LAND AT BATCHELORS FARM, KEYMER
ROAD, BURGESS HILL

STAGE 1 ROAD SAFETY AUDIT
RESPONSE REPORT

Project Title:	Land at Batchelors Farm, Keymer Road, Burgess Hill		
Client:	SDP		
Project Manager:	Michael Kitching		
Project Number:	SK21799		
Document Reference:	SK21799_2026RSARR02		
Document Type:	Road Safety Audit Response Report		
Primary Author:	Michael Kitching		
Approval Signature: Michael Kitching			
Directory & File Name:	P:\2017\PROJECT FOLDERS\SK21799\Technical\Reports\SK21799_RSARR02		
Issue	Date	Distribution	Comments
01	14/01/26	Project Team	Final Report
02	14/04/26	Project Team	Updated Report following WSCC Comments

Project: Land at Batchelors Farm, Burgess Hill	
Title: Proposed Access Location and Visibility Splays	
Scale: 1:1000 (@ A3)	
Drawing: 151112-01	Revision: -

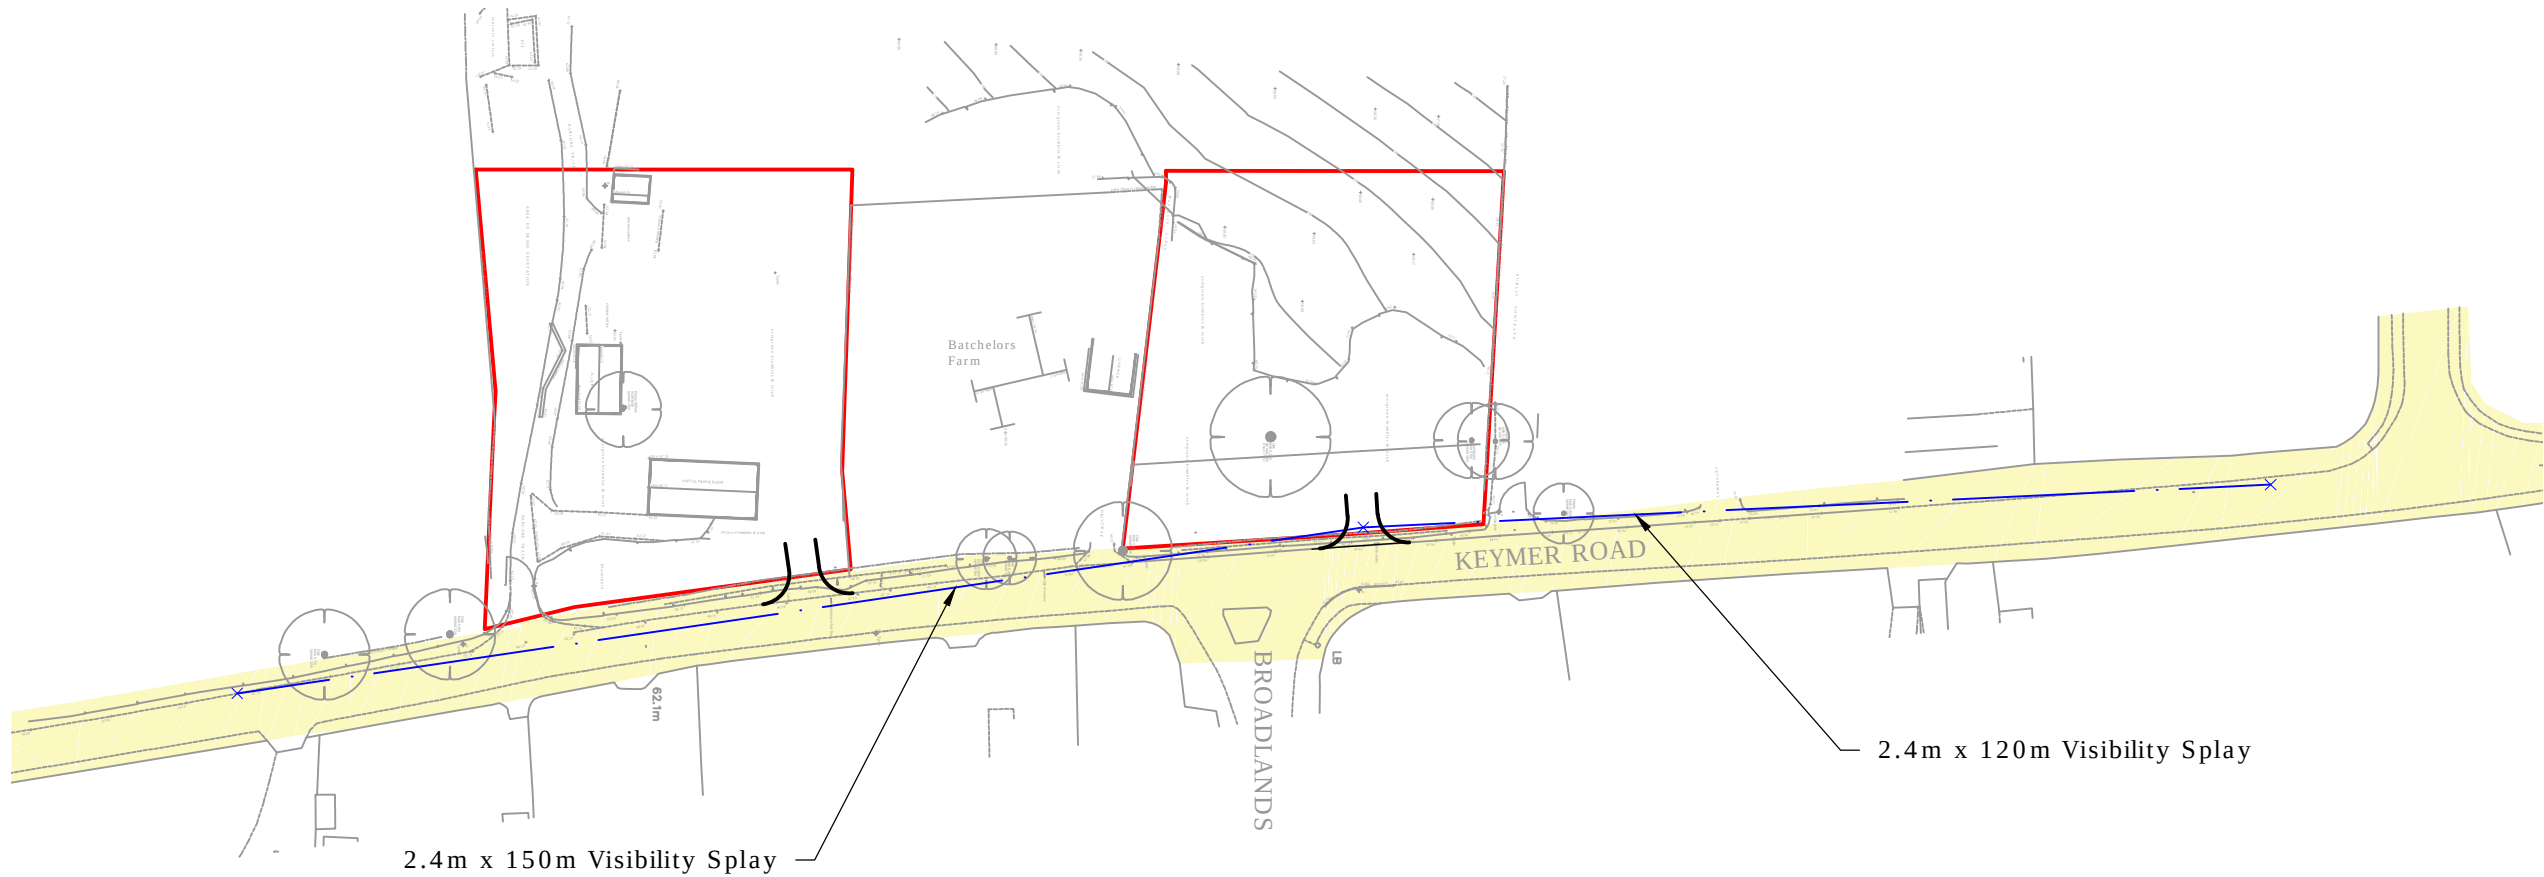
- 2.3 The auditors highlighted that the submitted drawings show visibility splays of 2.4m x 140m to the south of the southern junction, and 150m to the north of this junction. The team have highlighted that at the proposed northern access the previously approved visibility splay dimensions have not been notated on the plans.

- 2.8 In response to the RSA team's findings, we agree that all previously agreed visibility splays, that are shown on the previously approved 2015 access scheme drawings produced by Motion, and included in appendix j the SKTP Transport Statement will be provided. For ease of reference this drawing is provided again in **appendix c**.
- 2.9 To confirm, the 2015 approved visibility splays were dimensioned as:

Northern Access

- leading traffic direction (south) – 2.4m x 150m
- trailing traffic direction (north) – 2.4m x 120m

Southern Access

- leading traffic direction (south) – 2.4m x 140m
- trailing traffic direction (north) – 2.4m x 150m

Drawing Number
SK21799-04 REV H

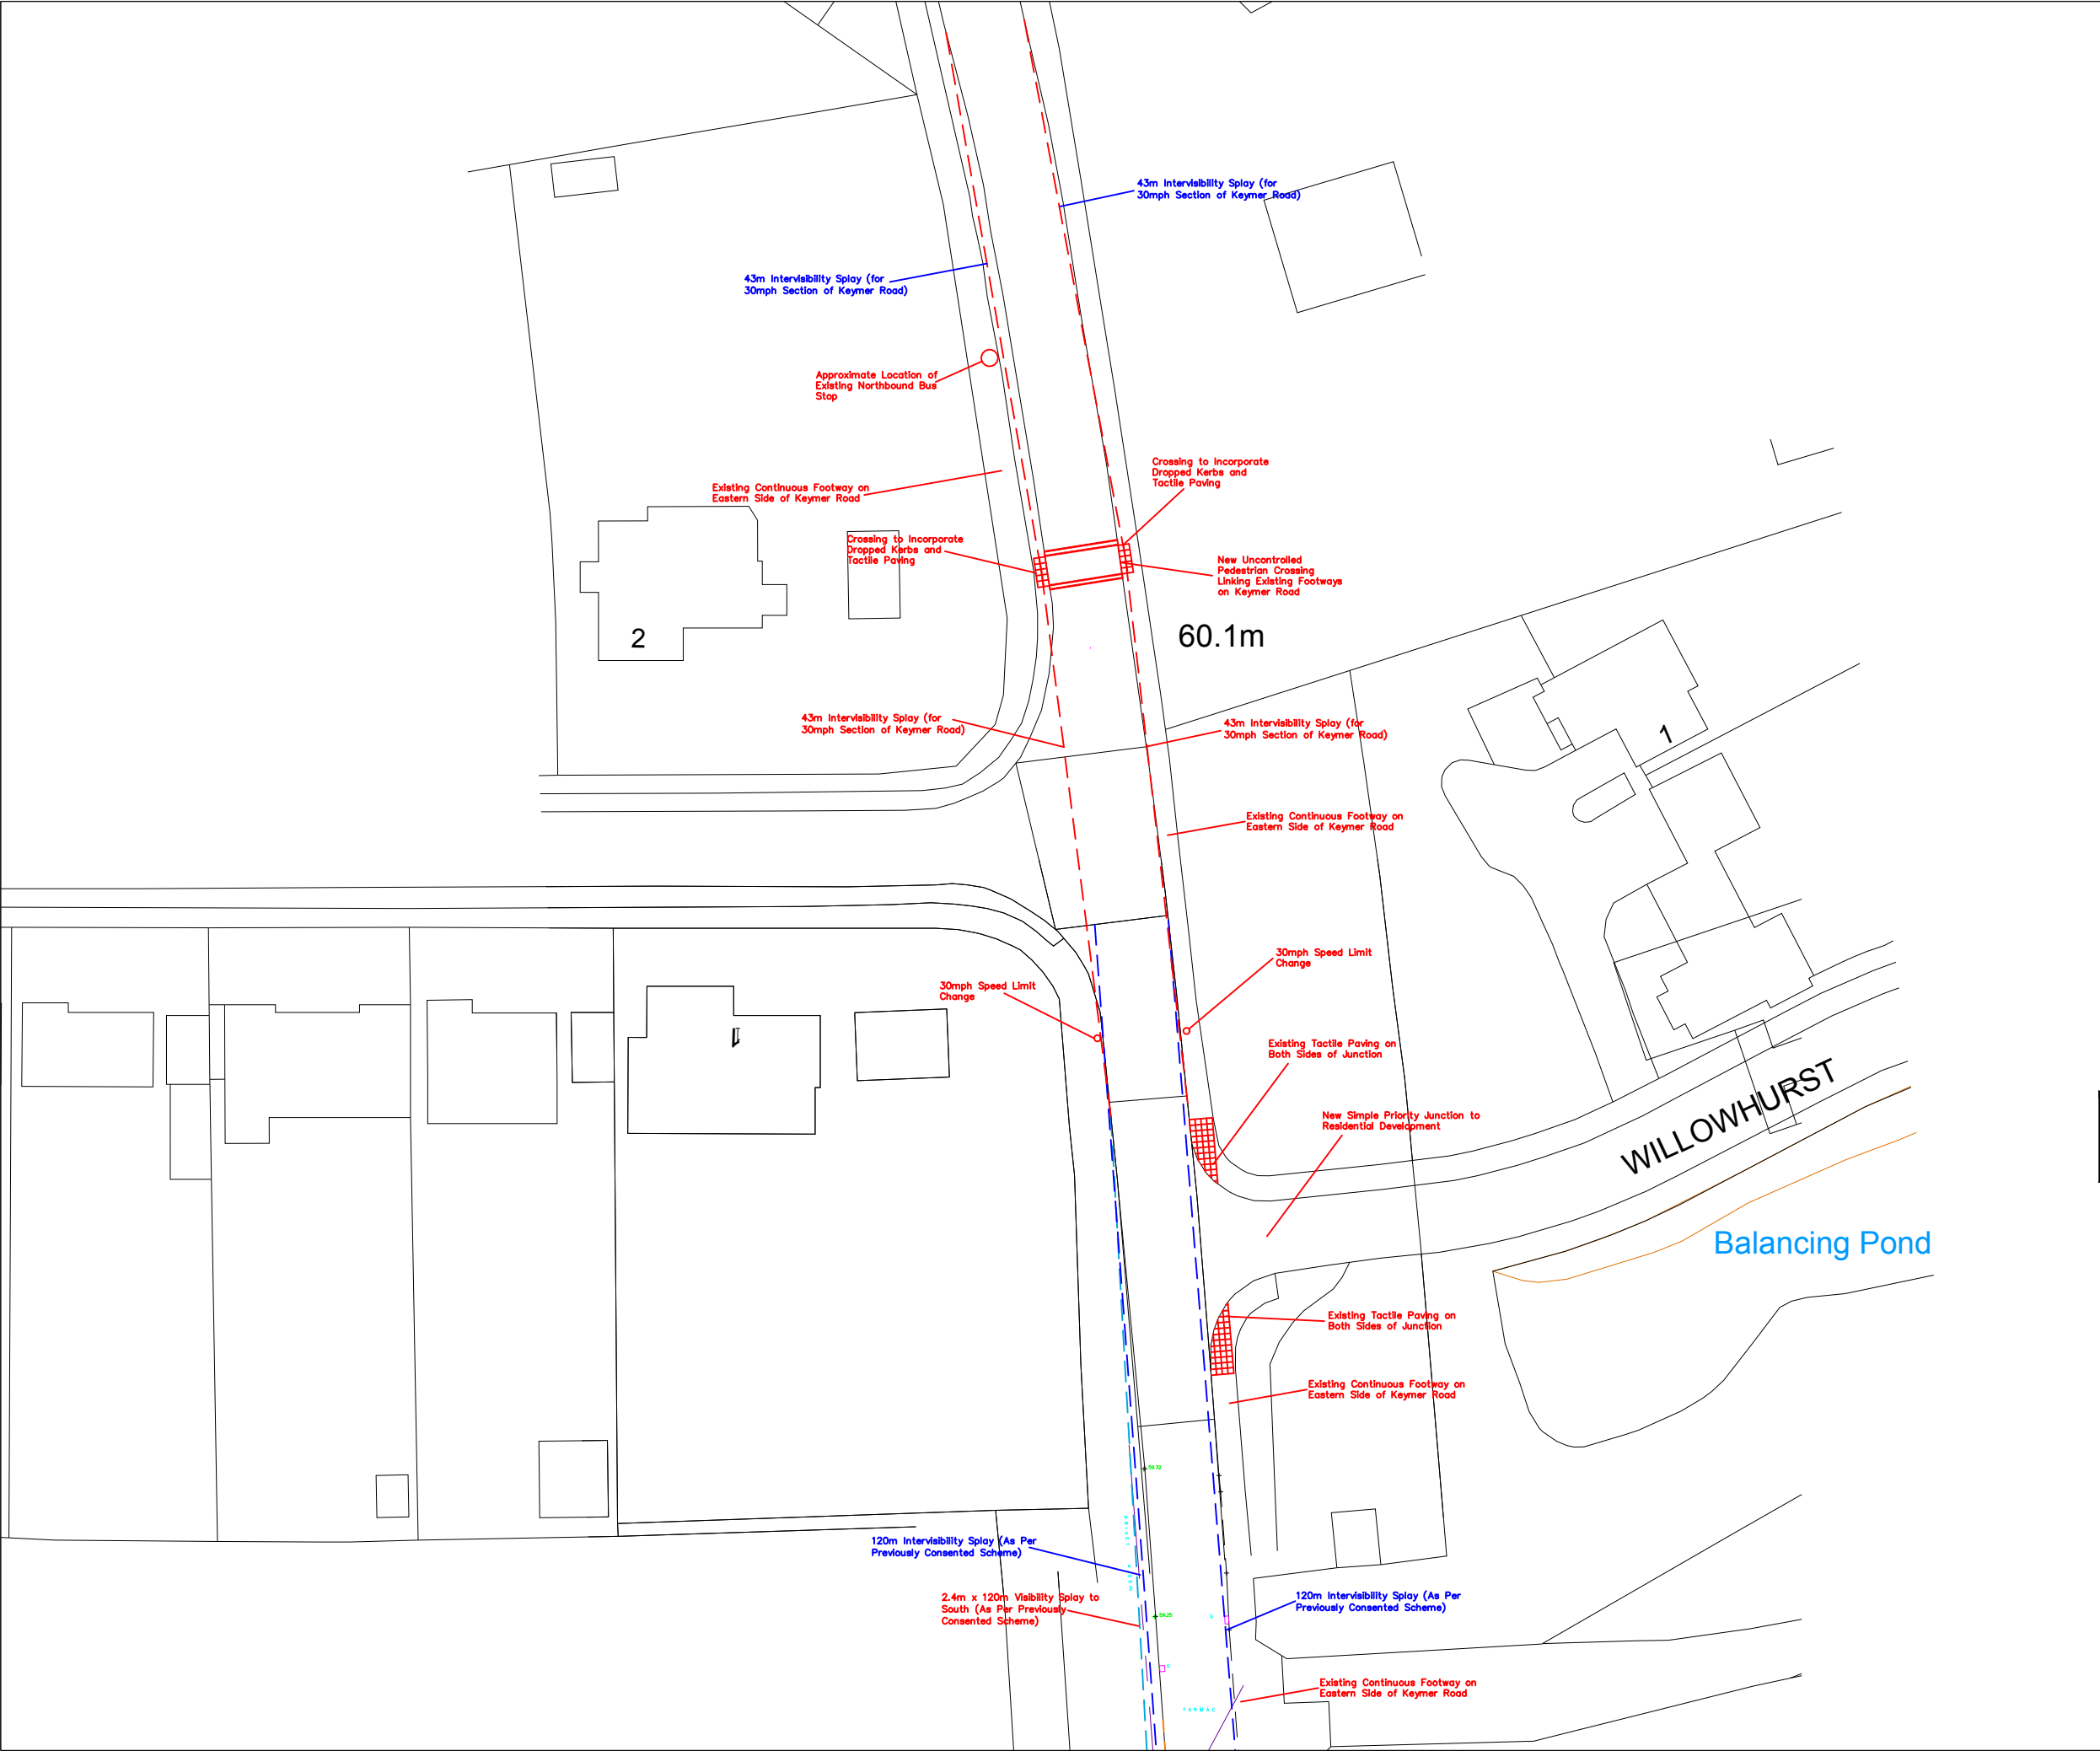
Problem 1: Restricted visibility at the proposed development site accesses could result in the potential increased risk of side impact collisions occurring

- 2.7 Additionally, it is recommended that values for the visibility splays at the northern access junction should be provided on the scheme drawings.

- 2.10 We can confirm that the above visibility splays will be delivered at the development site accesses, kept permanently clear of vegetation and obstructions, and maintained in perpetuity. The delivery of these visibility splays (and the site accesses) can be secured through an appropriately worded Planning Condition.
- 2.11 Following their review of the January 2026 RASRR, WSCC Highways Officers requested that a simplified set of plans showing the proposed visibility splays be prepared and submitted. In their initial response WSCC confirmed that they agreed in principle with SKTP's response in paragraph 2.10, but required a clearer set of plans to validate this position. These revised plans are provided in **appendix d**, and have been informally submitted and agreed in principle with WSCC.

Drawing Title
Pedestrian Enhancements 43m Intervisibility Splays from Northern Crossing Tactile Paving

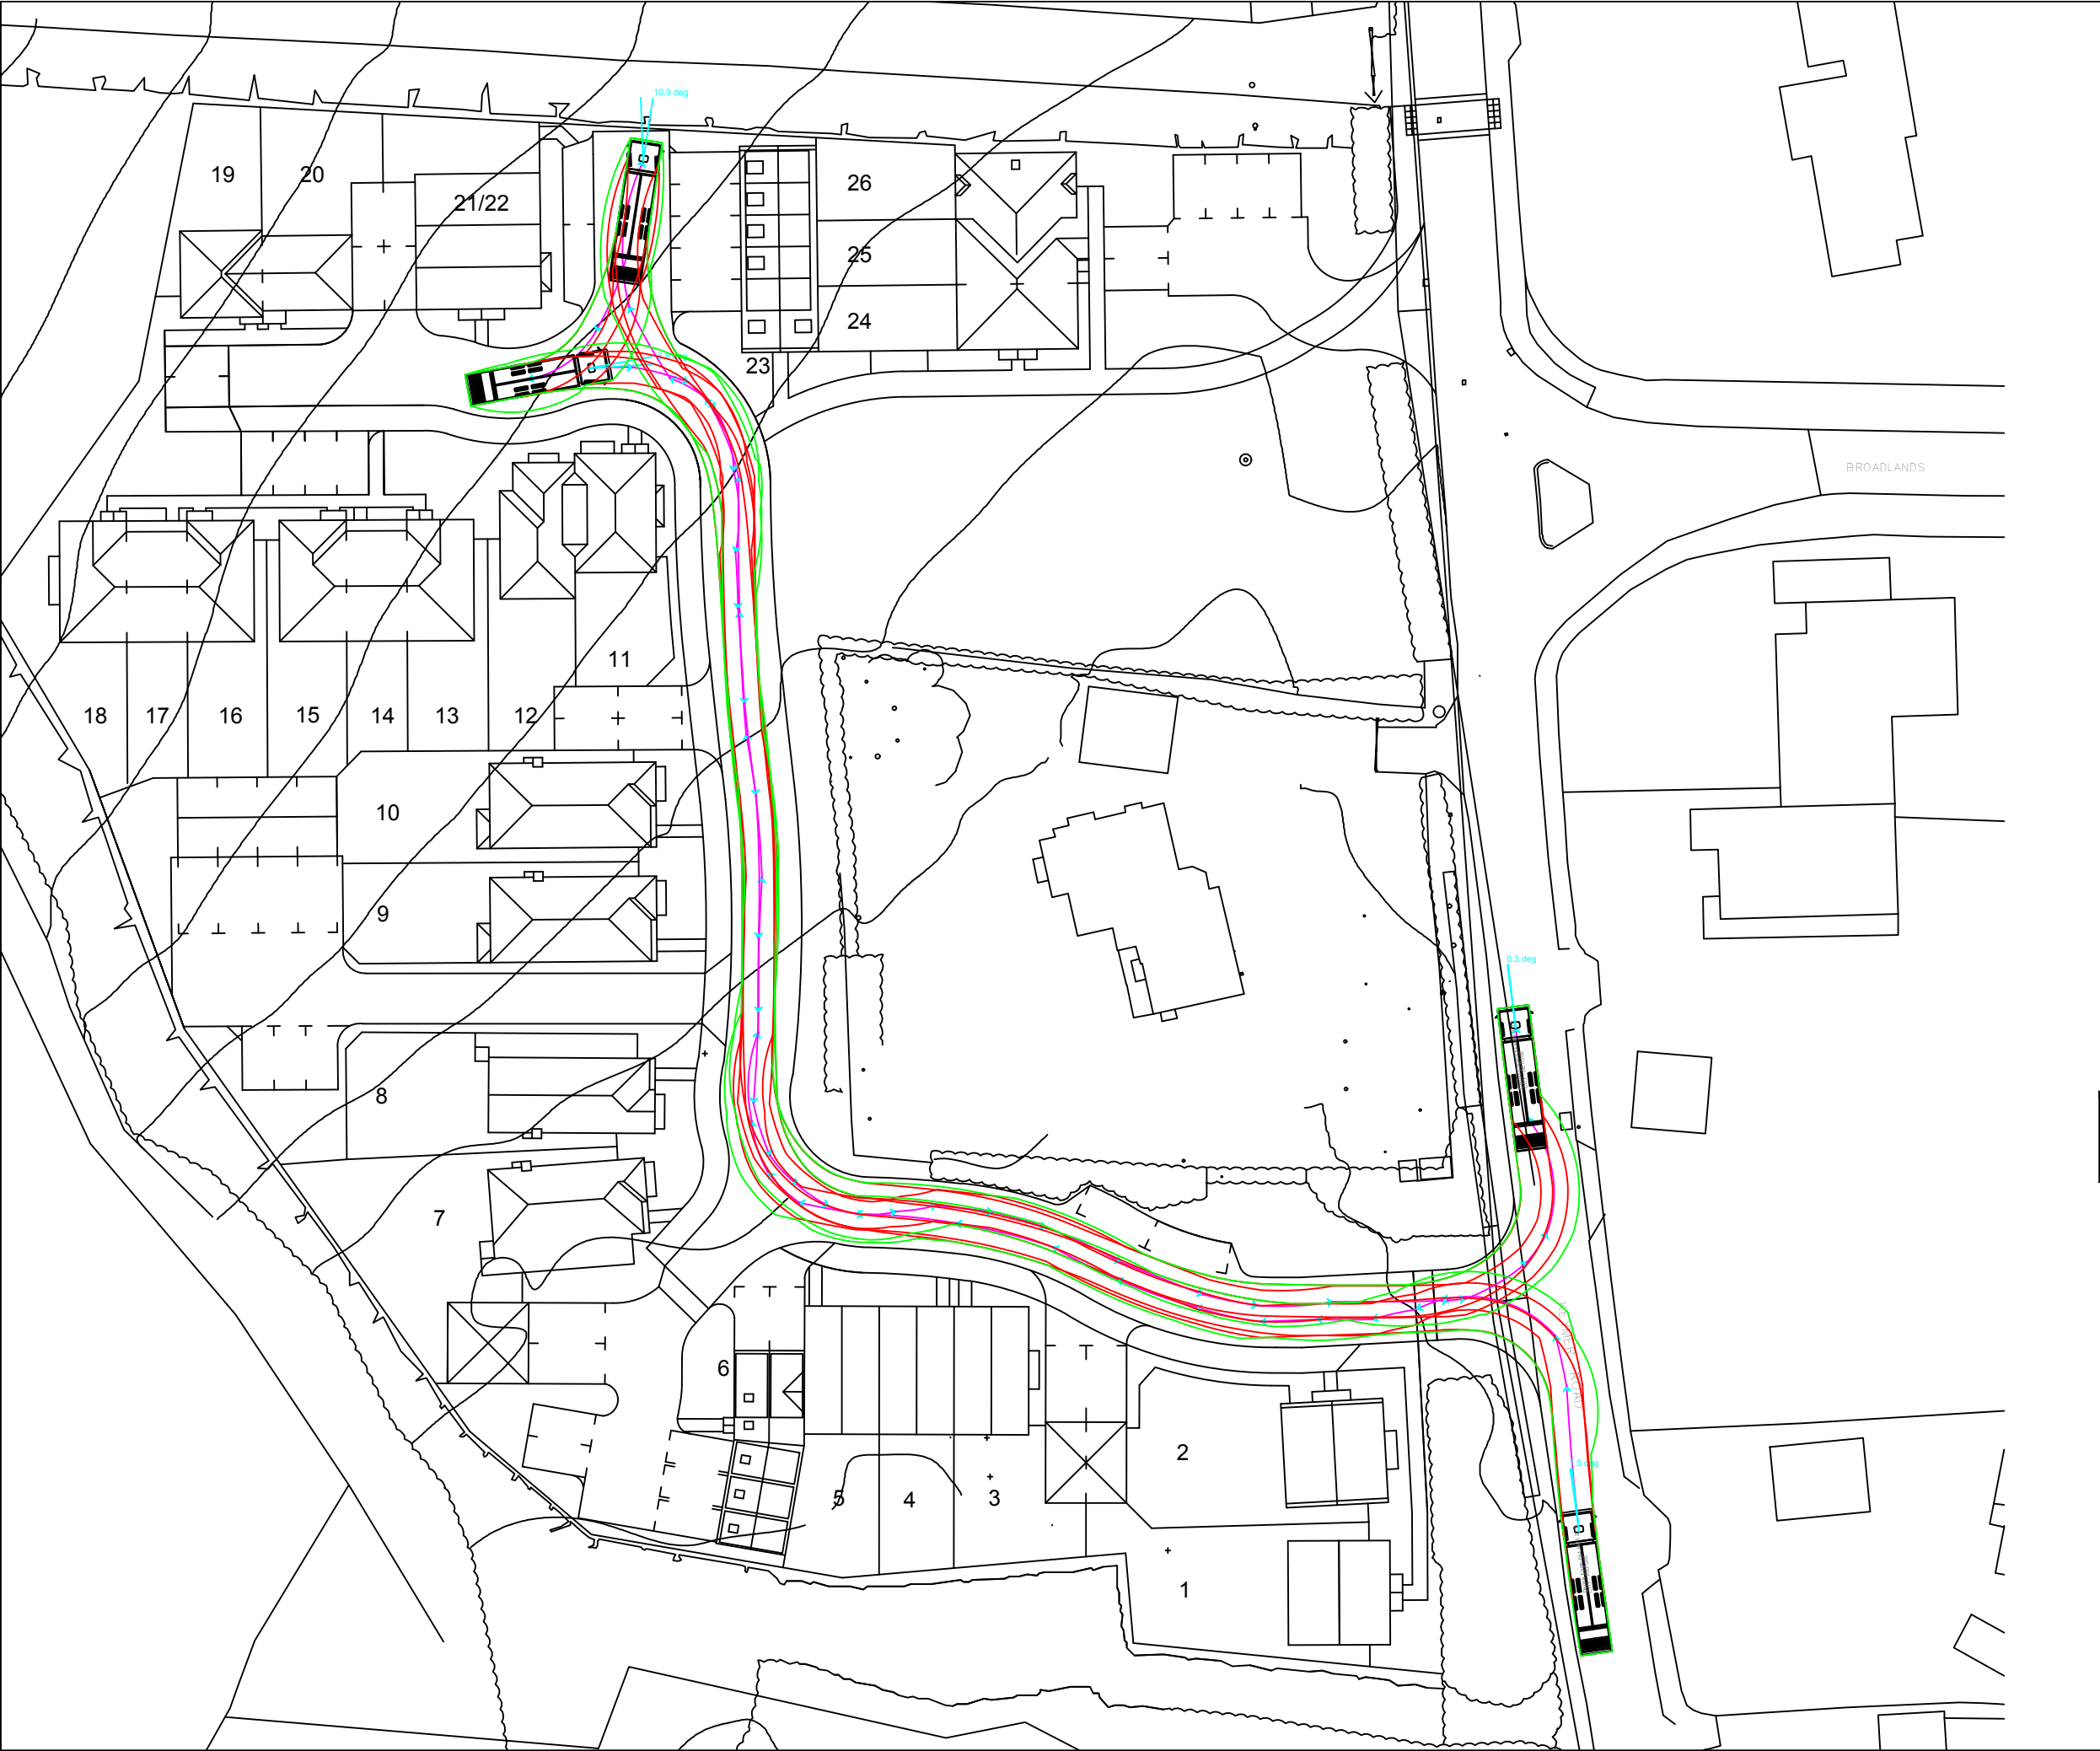
Problem 2: Restricted inter-visibility could result in a potential increased risk of vehicular and pedestrian collisions occurring

- 2.15 The RSA team has raised the concern that there is the potential for restricted inter-visibility between pedestrians crossing Keymer Road, particularly from west to east at the proposed northern and southern uncontrolled pedestrian crossing facilities and vehicular traffic on Keymer Road could lead to potential increased risks of vehicle/pedestrian collisions. This could result in pedestrians sustaining personal injury.

- 2.16 The RSA team has recommended that the intervisibility at the northern and southern uncontrolled pedestrian crossing facilities should be kept clear, by removing vegetation and street furniture (as required) to the rear of the footways. It is also recommended that the intervisibility distances should be provided on the scheme drawings.

- 2.17 In response to the RSA team's findings, we agree that appropriate levels of intervisibility should be provided between pedestrians standing on the tactile paving on the eastern and western sides of the crossing points, and the drivers/riders of vehicles using the Keymer Road.
- 2.18 The achievable intervisibility splays are shown on plan in **appendix d** at both crossing points, and can be secured in perpetuity through an appropriately worded Planning Condition. These are the plans requested by WSCC's Highways Officer following their review of the original RSARR, to show the splays on simplified base mapping.
